Evaluation of Grid-Connected Photovoltaic Systems at The Nature Conservancy – Disney Wilderness Preserve

FSEC-CR-1661-99

**Prepared by
Florida Solar Energy Center
November 1999**

Figure 6. System #2 source circuit combiner box.

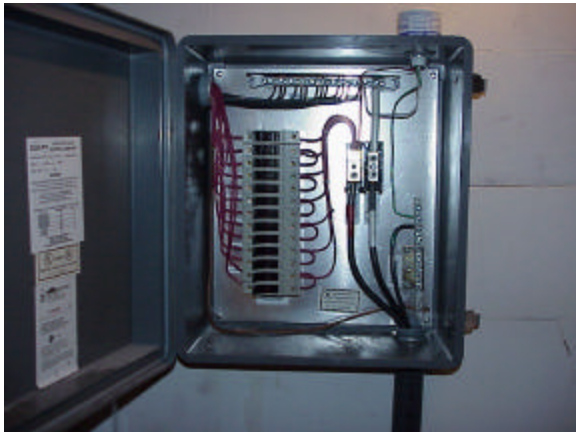
The inter-module and source circuit wiring terminations are the same as for System #1, except for the thirteen (13) source circuits are combined in a single combiner box, located in the attic (Figure 6). The length of wiring from the terminal block in the combiner box to the inverter is approximately 1 m (~3 ft) - as the inverter is also located in the attic for System #2 - and uses #4 AWG THW conductors. System #2 uses the same Trace Engineering model SW5548 line-tie inverter as System #1, however this unit is only operated at a lower power level (Figure 7). The AC output from the inverter is connected to a double-pole 30-amp branch circuit breaker in the distribution panel for the southernmost building using #10 AWG THWN conductors in ½-inch EMT.

Figure 8. Seam between PV and conventional metal roofing.

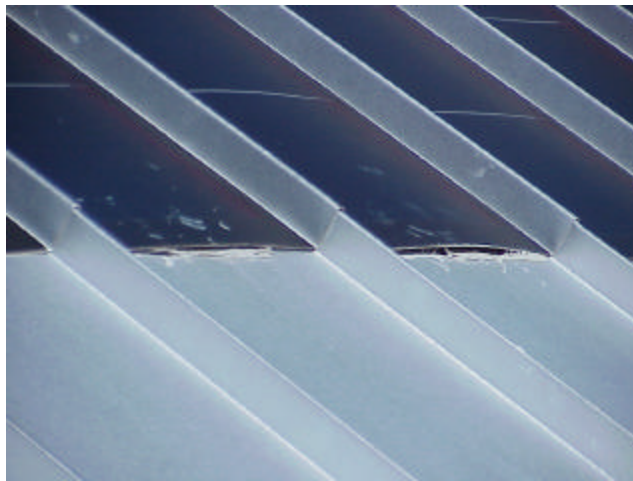
- A seaming problem exists between the PV and conventional metal roofing on the System #2 array. Attempts to seal the roofing at this point with caulking appear to have failed and the PV-integrated roof panels were bowed up slightly (Figure 8). Depending on the amount of overlap at the seams, this could potentially lead to a weather-sealing problem during wind-blown rain from the south.

Figure 10. Burn marks below AC breaker on System #1 inverter.

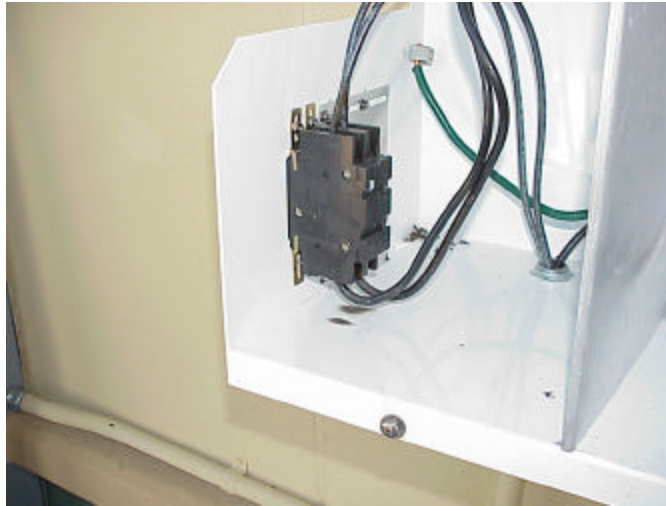
- When the case was first removed on the System #1 inverter, burn marks were noticed on the cabinet beneath and to the side of the 35-amp main AC circuit breaker (Figure 10). This was reported to have been a lightning event that occurred before the system was operational, however no obvious damage to the breaker or the inverter were found, and the system was functioning normally. Special attention should be paid to this device for heating or other problems that might occur.
